**NOTICE TO BIDDERS D
HARBOR-UCLA MEDICAL CENTER REPLACEMENT PROGRAM
GENERATOR BUILDING RETROFIT PROJECT COMPONENT
BID NUMBER: BRC0000569
SPECS 7962; C.P. 67961**

April 16, 2025
REQUEST FOR INFORMATION/CLARIFICATIONS
HARBOR-UCLA MEDICAL CENTER REPLACEMENT PROGRAM
GENERATOR BUILDING RETROFIT PROJECT COMPONENT
BID NUMBER: BRC0000569

EXHIBIT 14 - Addendum D

1. Addendum D Narrative: Prepared by RBB Architects dated April 11, 2025

DESCRIPTION
PLUMBING PARTIAL SITE PLAN

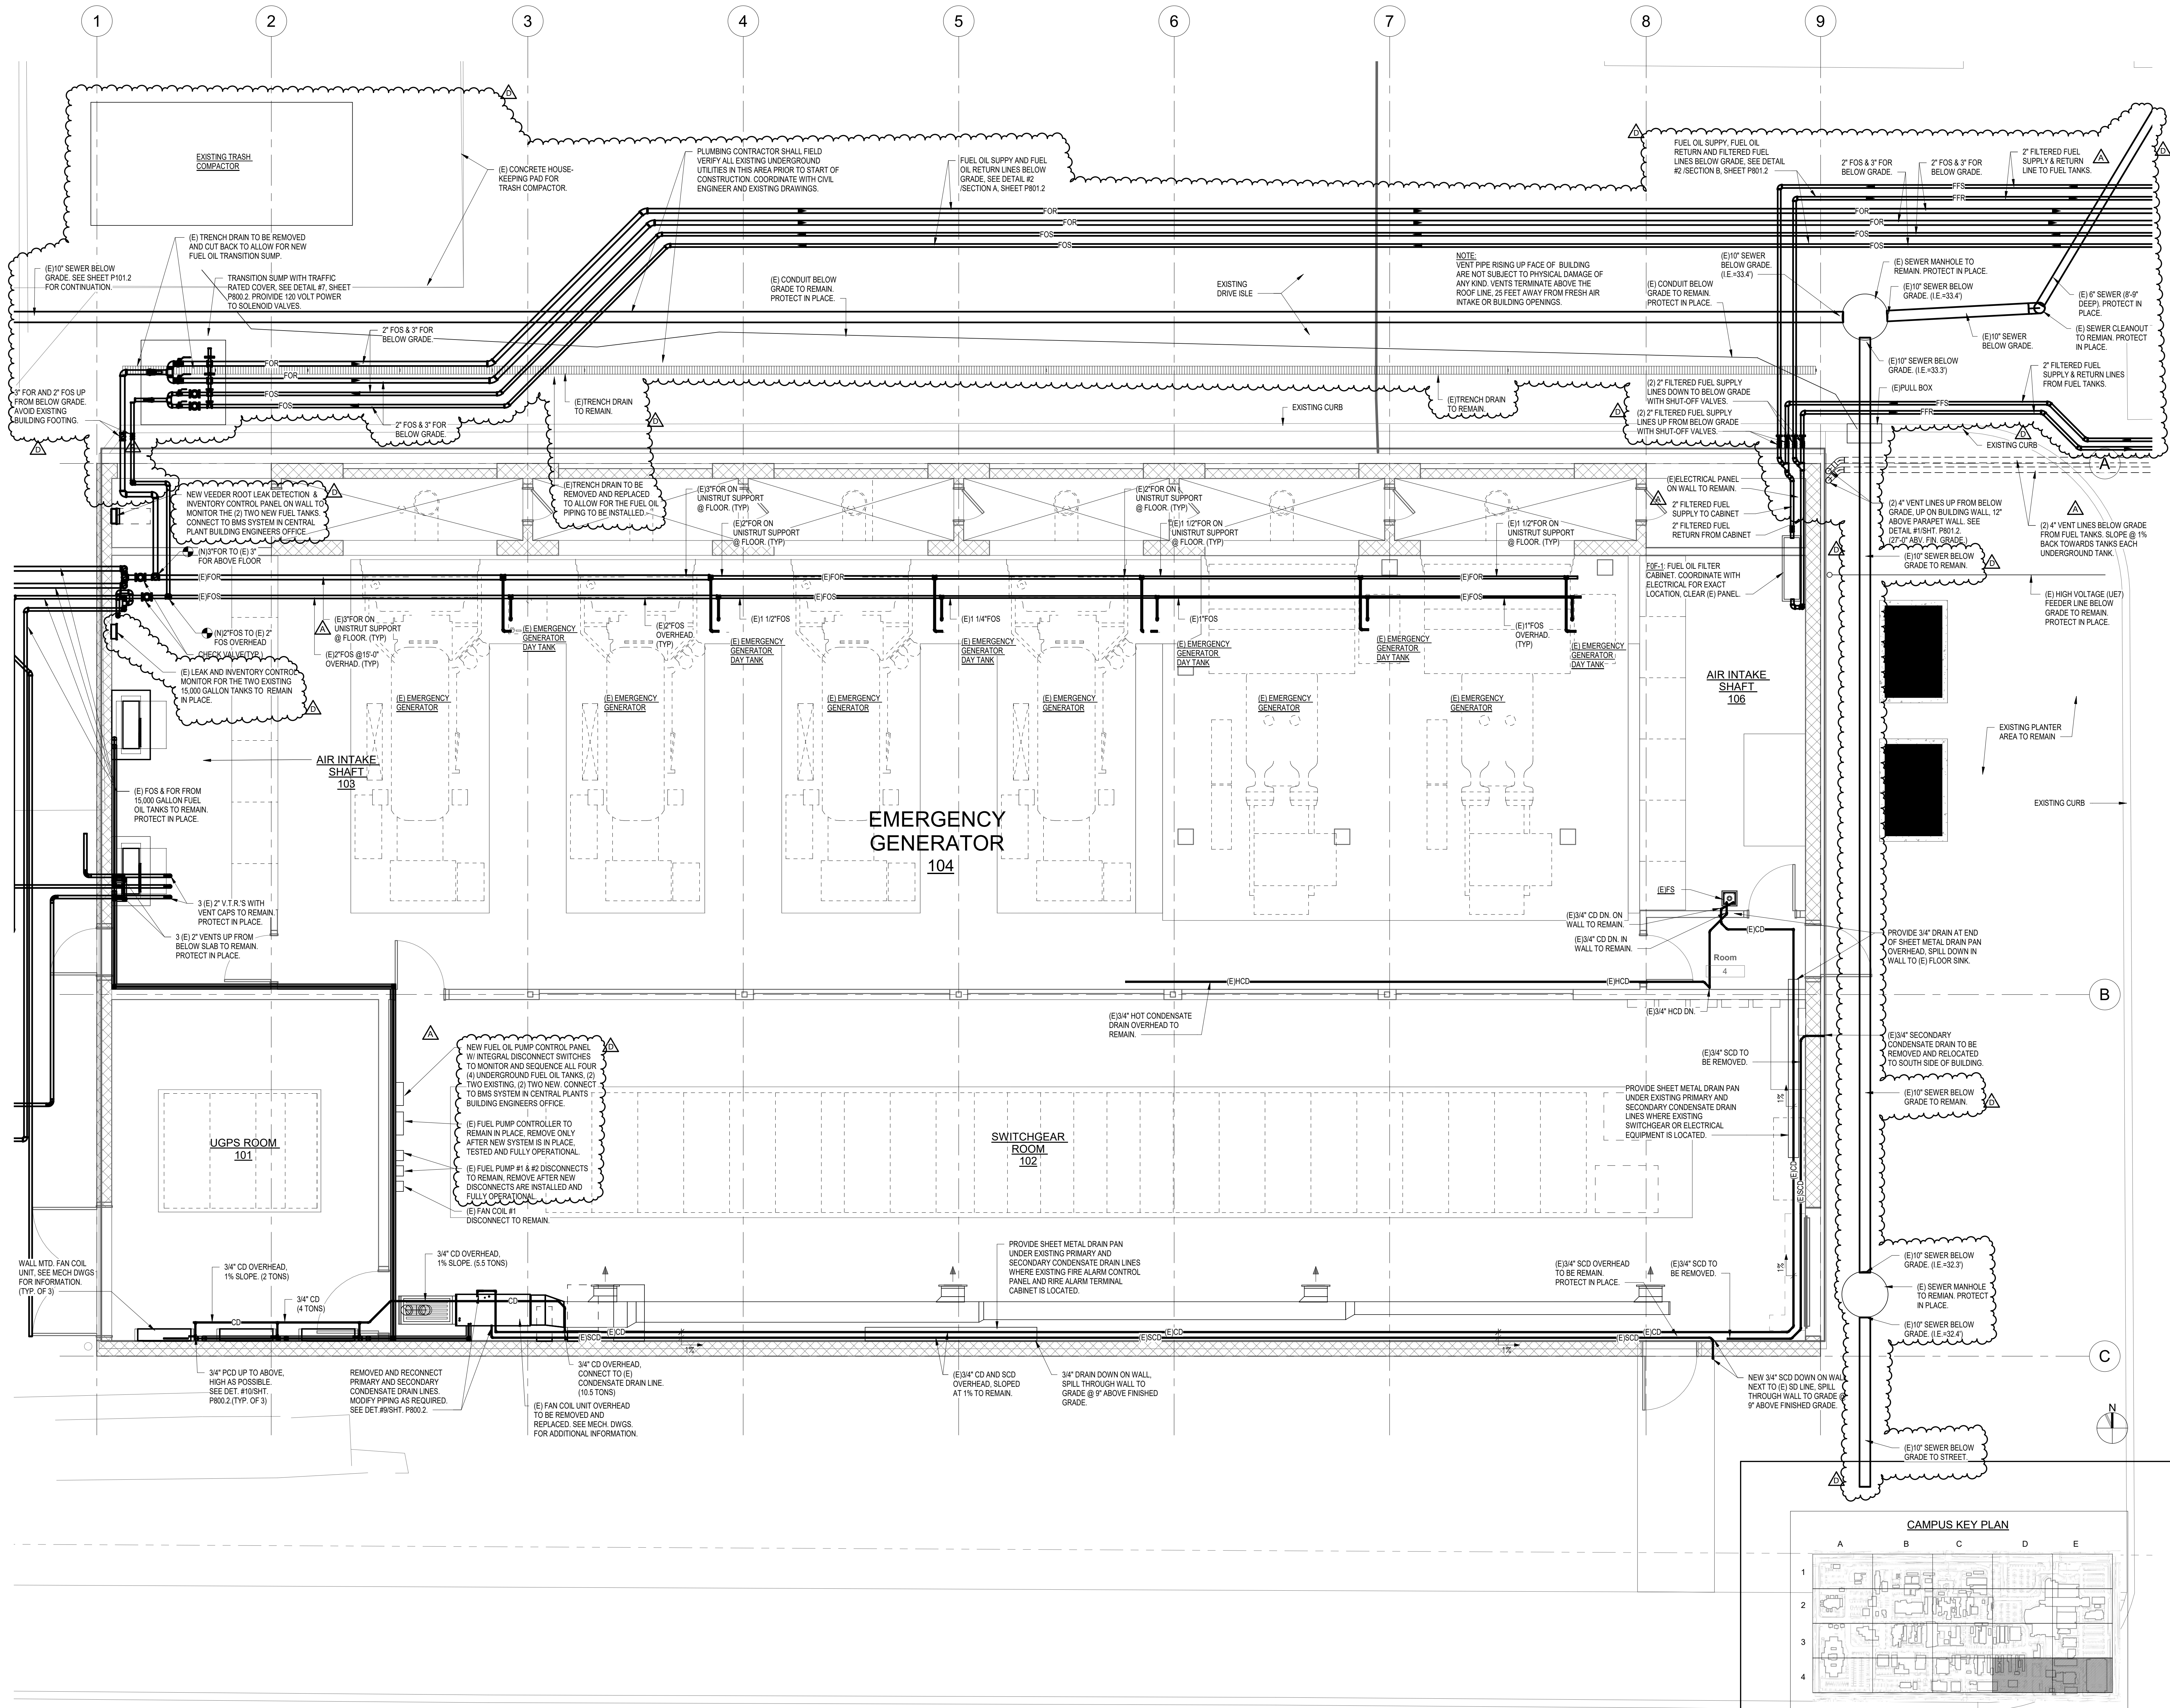
- P101.2** – Plumbing Partial Site Plan - Added the existing utilities, i.e. sewer, storm drain, and electrical lines to the Site Plan. Rerouted the Fuel Oil supply and return piping to avoid the existing underground utilities. Revised plumbing notes to reference the correct details. Added the Fuel Tank Overfill Alarm location at each tank. Indicated the location of the Building Engineers office in the Central Plant.

DESCRIPTION
PLUMBING LEVEL 1 PLAN

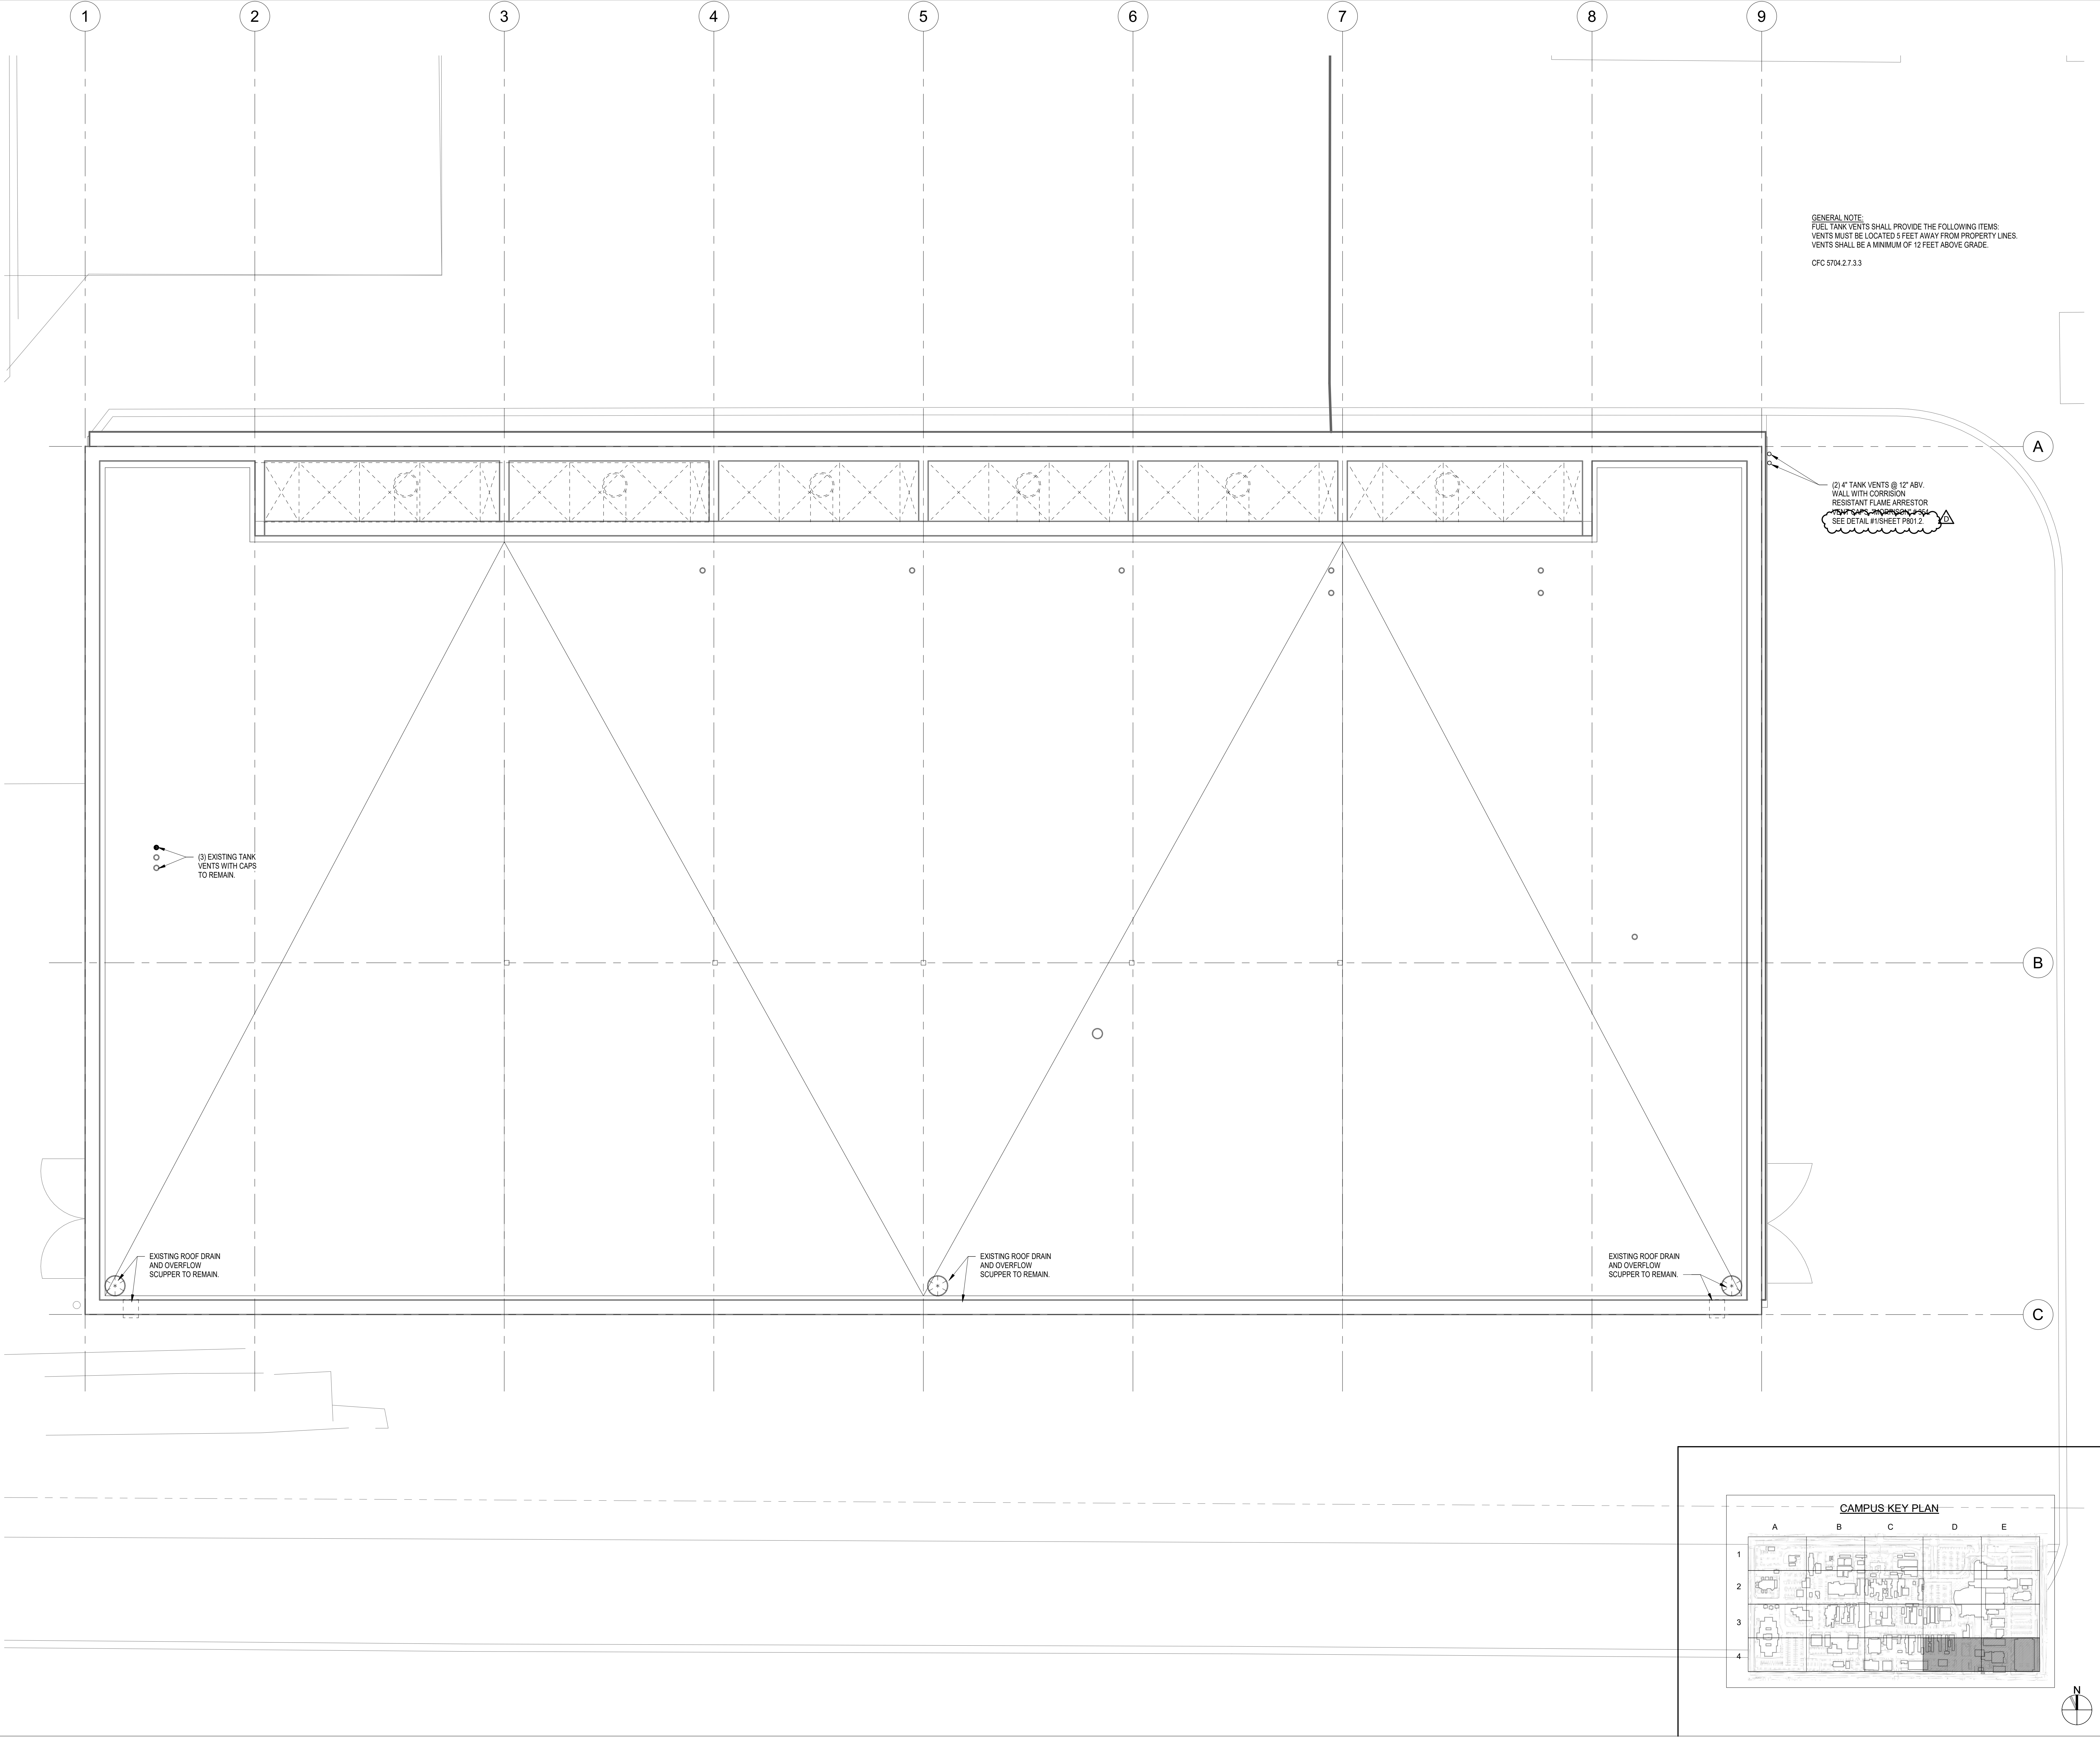
- P211.2** – Plumbing Level 1 Plan - Added the existing underground utilities on this sheet for reference. Relocated Fuel Oil Filter inside the building to avoid the existing electrical panel. Revised plumbing notes for the new fuel pump control panel. Revised the plumbing notes at the existing and new leak and inventory control and monitoring panels. Relocated the transition sump, supply and return lines into the building to avoid the existing underground utilities.
